SCHNITZER STEEL INDUSTRIES, INC.
25 Sandquist Street Concord, New Hampshire 03301-3558
Phone: (603) 225-2267 Fax: (603) 225-0656

January 20, 2015

Re: Response to Review Comments
Standard Permit Application
New England Metal Recycling LLC
Madbury, New Hampshire
WMD Log #2011610, 2011660, 2011730, 10779, 12731, 12977, 13049, 13125, 13177, and 13206

FIGURE NUMBER: 5.2

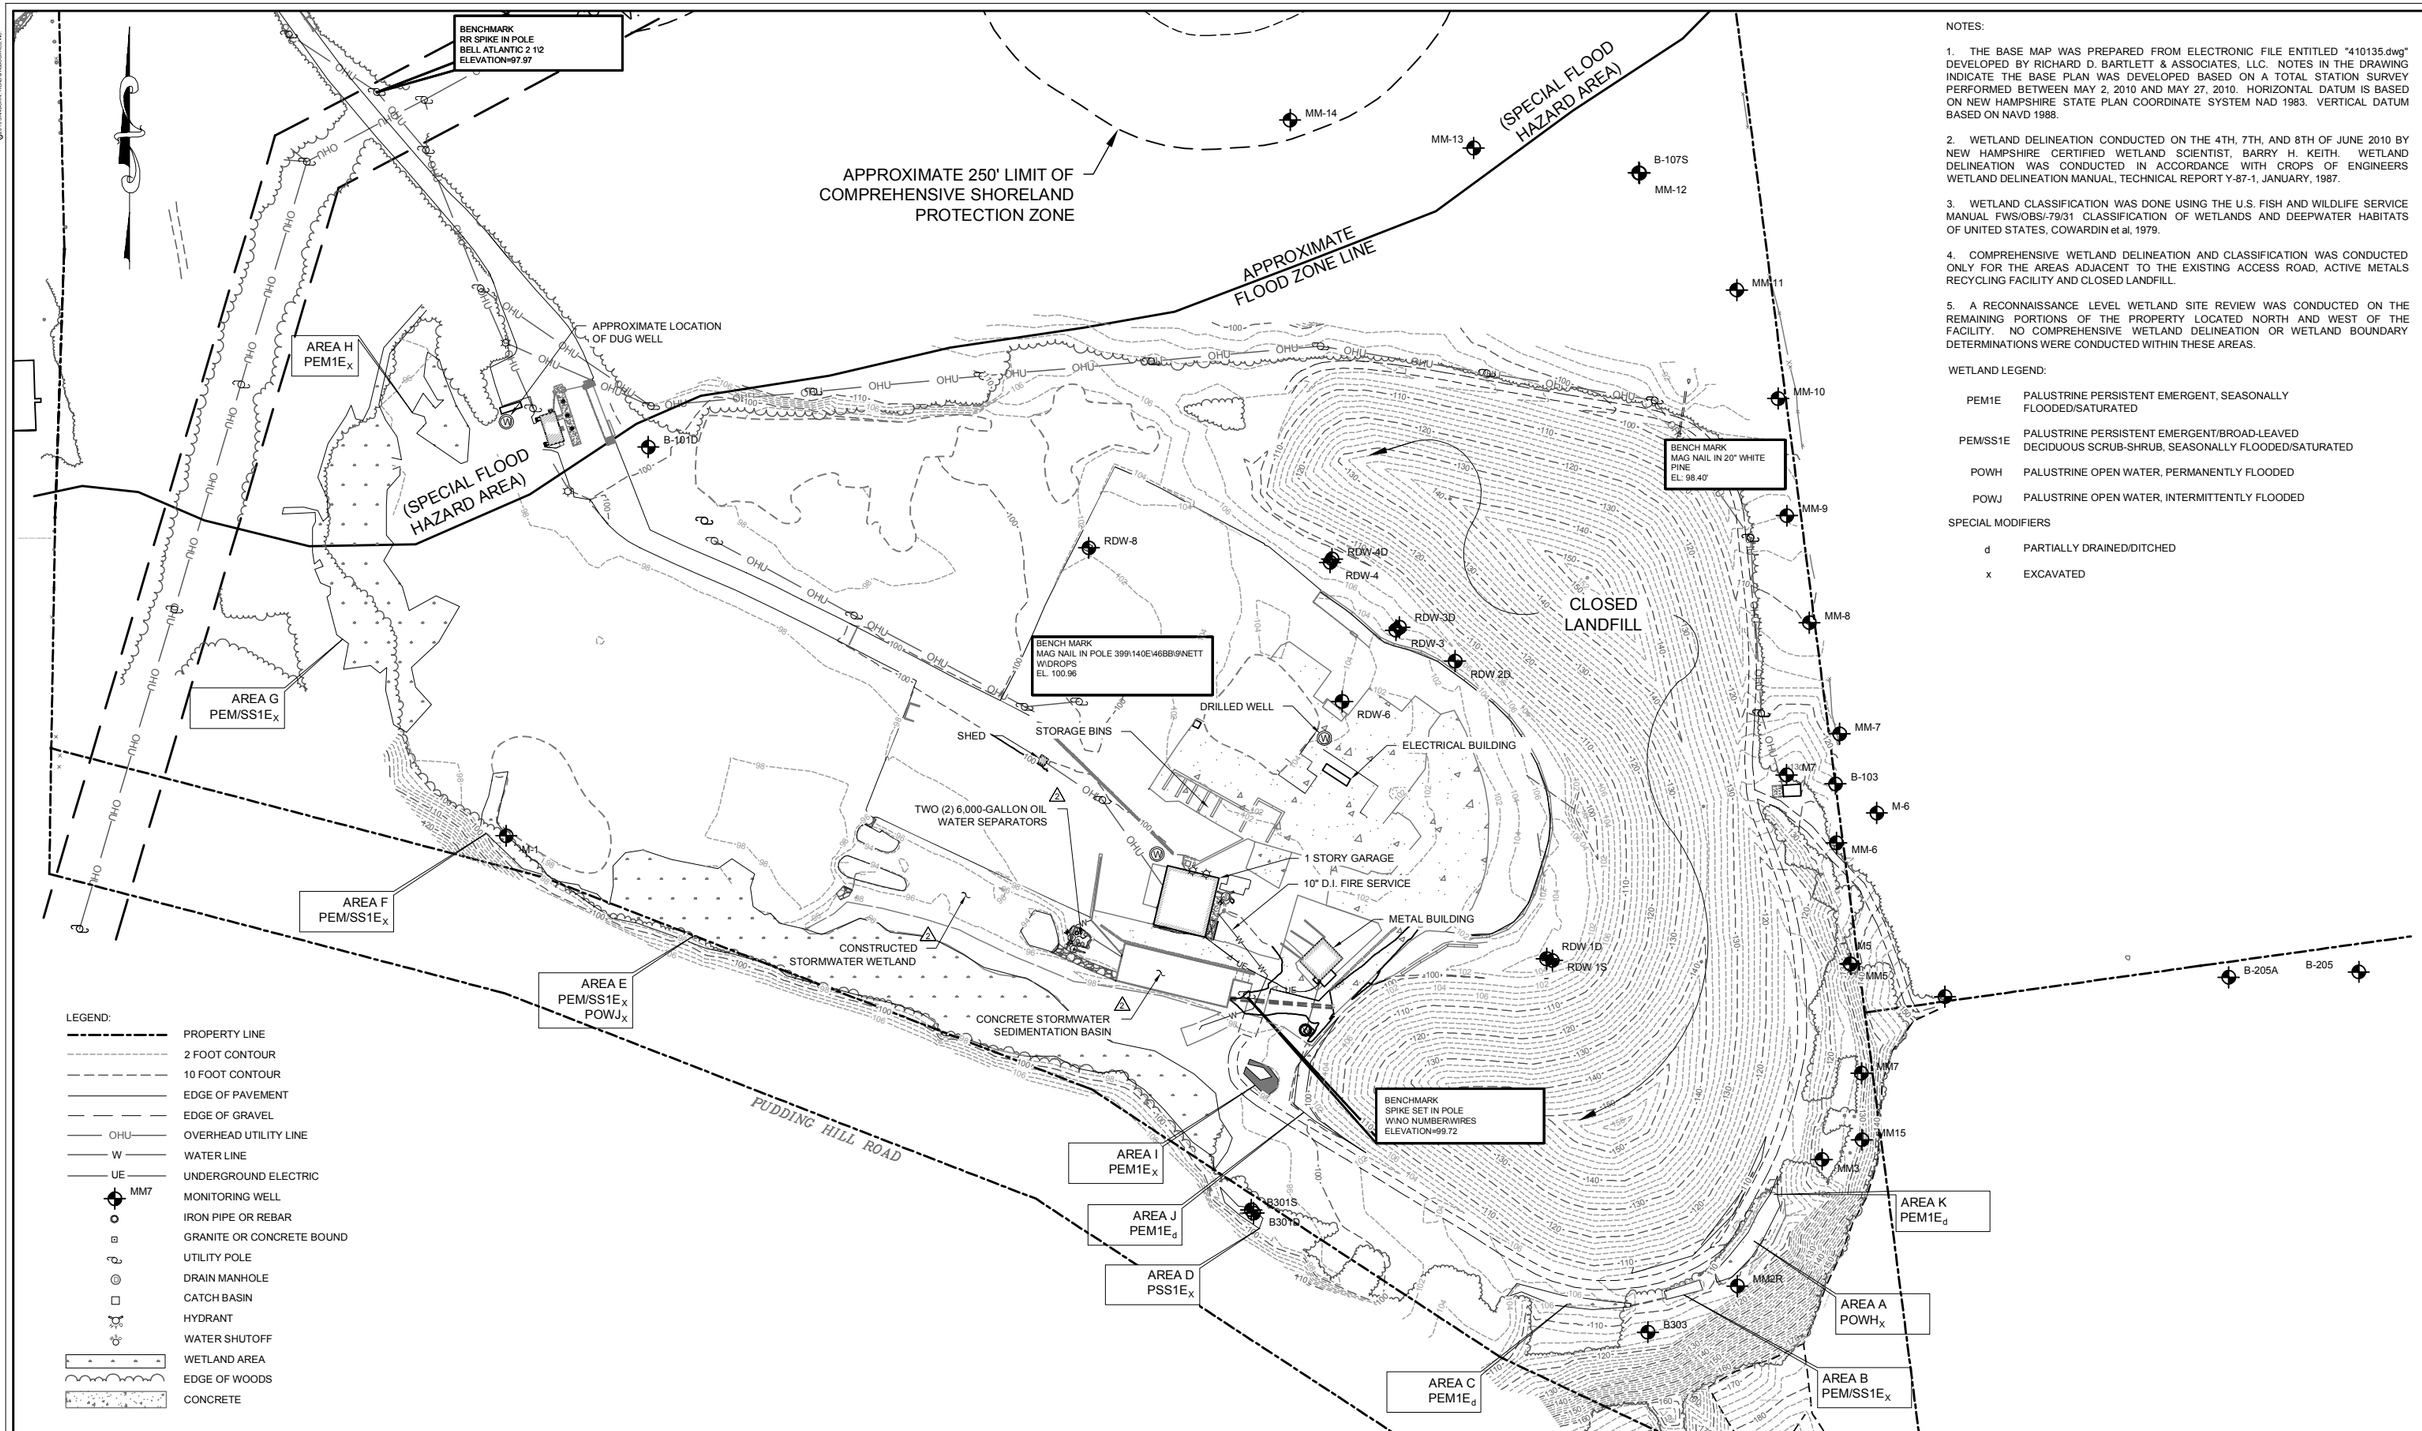
1. *Section 5.0, Facility Maintenance, Inspection and Monitoring Plan, does not mention the oil/water separator (OWS) at the facility. The last mention of the OWS in the Hazardous Waste Remediation Bureau files is in the 2009 Annual Summary Report, dated January 27, 2010 prepared by EOS Research, (Ltd.) (EOS). EOS refers to the OWS as follows "The OWS was replaced during 2009 with an engineered stormwater treatment system that includes particulate settling, oil/water separation, and constructed wetlands. Periodic Cleaning of the oil/water separator will continue to be performed during 2010." If the OWS is still functioning for its intended purpose, please identify its location, and provide the operation and maintenance procedures for the its inspection, pumping and reporting.*

There are two (2) 6,000-gallon oil water separators that were installed at as part of the engineered stormwater treatment system in 2009. A description of the stormwater treatment system and the operation and maintenance procedures have been added to Section 5.0 of the Operating Plan.

REVISED SECTION 5.8 OF THE FACILITY OPERATING PLAN
AND
FIGURE 5.2 SHOWING LOCATIONS OF STORMWATER TREATMENT FEATURES

SITE LAYOUT

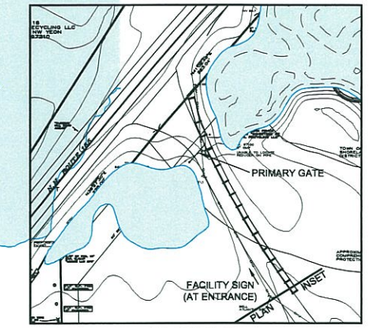
1. *The 100-year floodplain shown on Sheet 2 is different than the floodplain shown on Sheets 1 and 3. Please explain. Please insure the floodplain is the same on all full-size and half-size sheets, and that a reference to the source of this floodplain elevation is shown on these full-size and half-size sheets.*

The 100 year floodplain that was shown on Sheet 2 was based on an analysis of FEMA mapped floodplain elevations and site topography as previously described in our letter responding to DES's October 9, 2013 comment letter. The 100 year flood plain lines shown on Sheets 1 and 3 were digitized from the effective Flood Insurance Rate Map (FIRM). Attached to this response are revised drawings that show both the estimated 100 year floodplain limit based on the analysis of FEMA mapped floodplain elevations and site topography (shaded in blue) and the 100 year floodplain limit digitized from the FIRM on each sheet.
